SDR PCB and Schematics Corrections for YU1LM/QRP Projects

Here is list of all my errors in my 3 articles which I knew in this moment. I am so sorry for them and I am apologizing to all for inconveniences. I also want to thank you to all who send me messages about my designs and especially for mistakes which you have found.

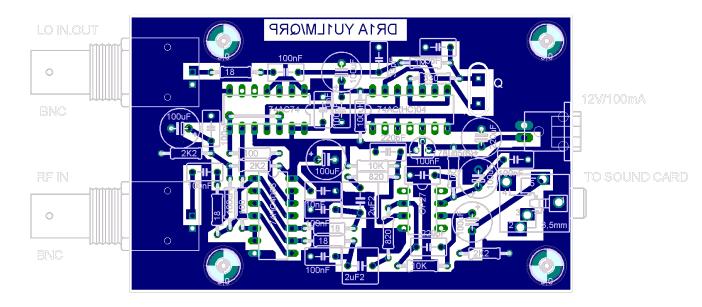
- -in DR1 78L05 is not oriented correct (turn on it for 180 DEG and shape GND pin)
- In schematic VCC for 74AC02 I missed one choke 100uH, 100uF and 100nF
- -better values for R7, R8 are 1K instead 2K2, better ½ VCC divider
- -better values for R11, R12in DR2 are 1K instead 2K2, better ½ VCC divider

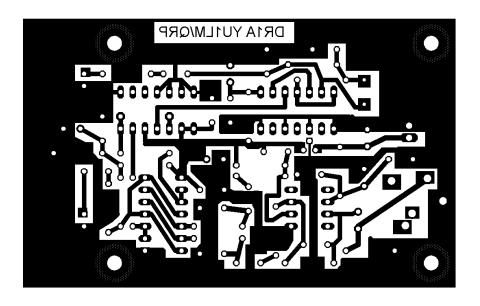
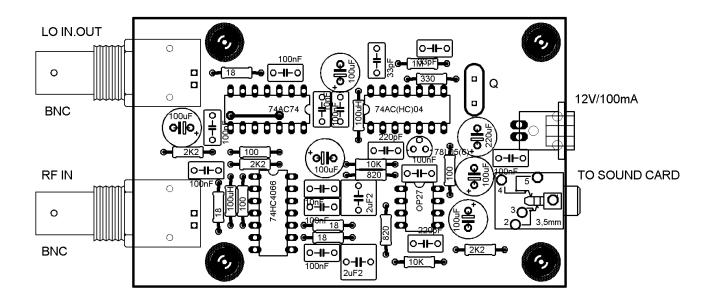
-for IC1 74HC4066 I missed choke 100uH, 100uF and 100nF in +VCC branch

2 DC 12V/100mA HF I/Q SDR Transmitter DT2A PC Sound card ⊕5 SnF2 C24 +VCC IC3 30 kHz-35 MHz YU1LM/QRP ANTENNA LOW-PASS OR BAND-PASS FILTERS X5 Flo max 125-140 MHz (see text) 10 dBm (for max Flo)

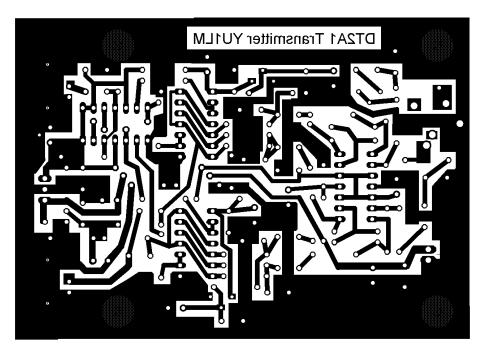
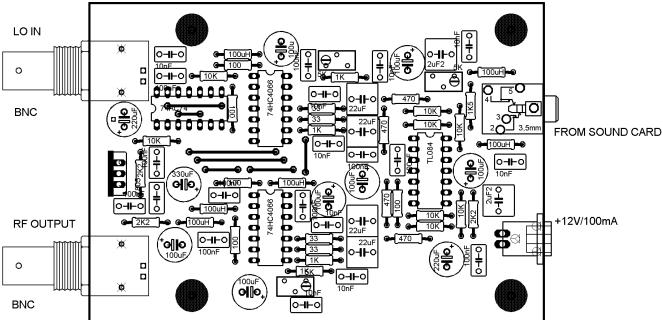
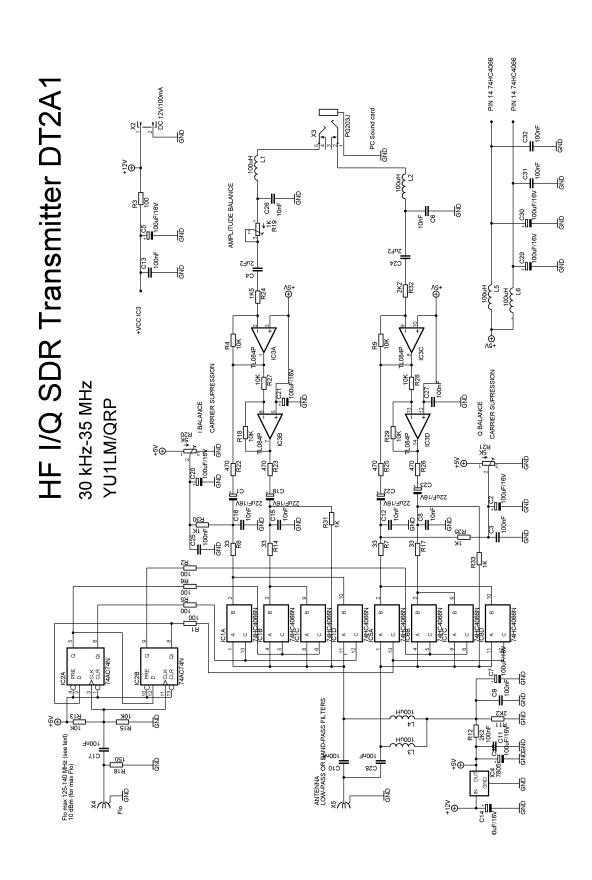
DR1A correct schematic PCB is down (I turned for 180 DEG 78L05)

For DT2A SDR Transmitter I published wrong version of schematics. Correct schematic is shown down and PCB published previously was for the DT2A transmitter.

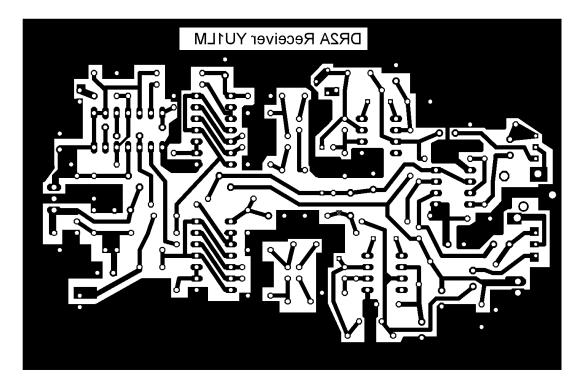
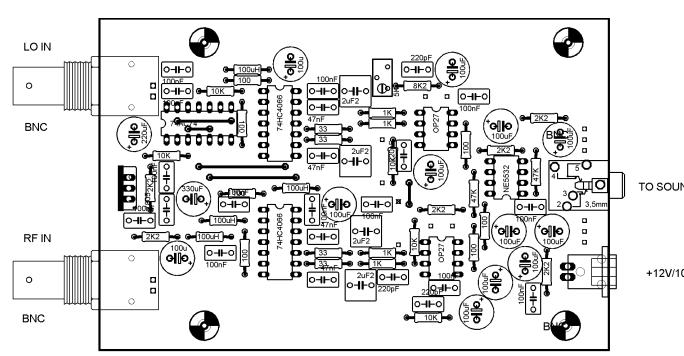
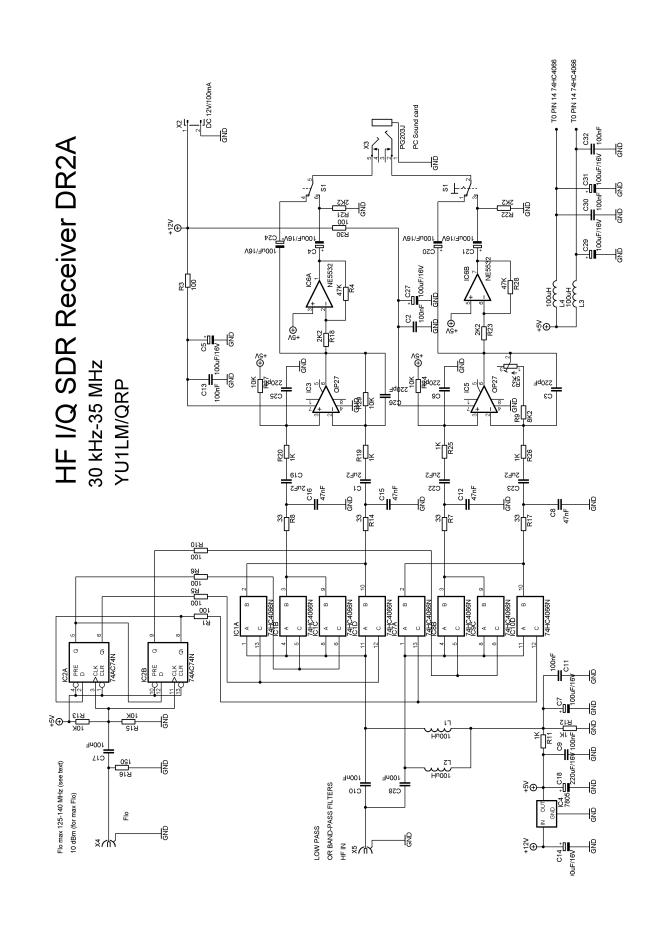
PCB and parts placement at site article is for this schematic up. DT2A schematic at site is DT2A1 version of DT2A and PCB for it is down with parts placement. I also propose new PCB with lower LO leakage and better LO suppression than original DT2A.

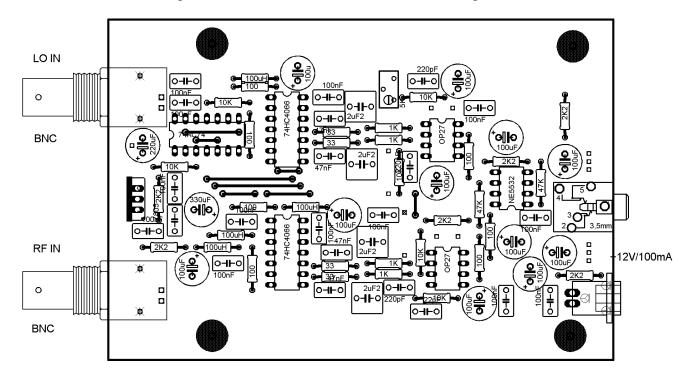
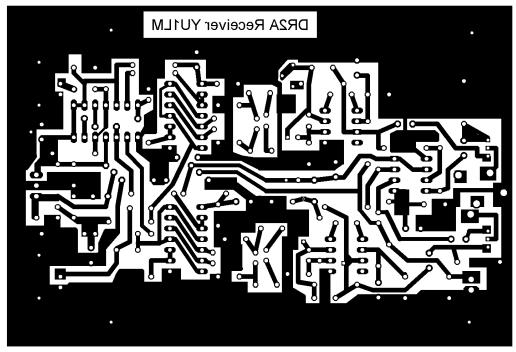
These corrections are for the third part. DR2A have minor changes and correct schematics PCB and placement for DR2A RX are down.

In meanwhile I made improved PCB for DR2A RX to lower LO leakage see down.
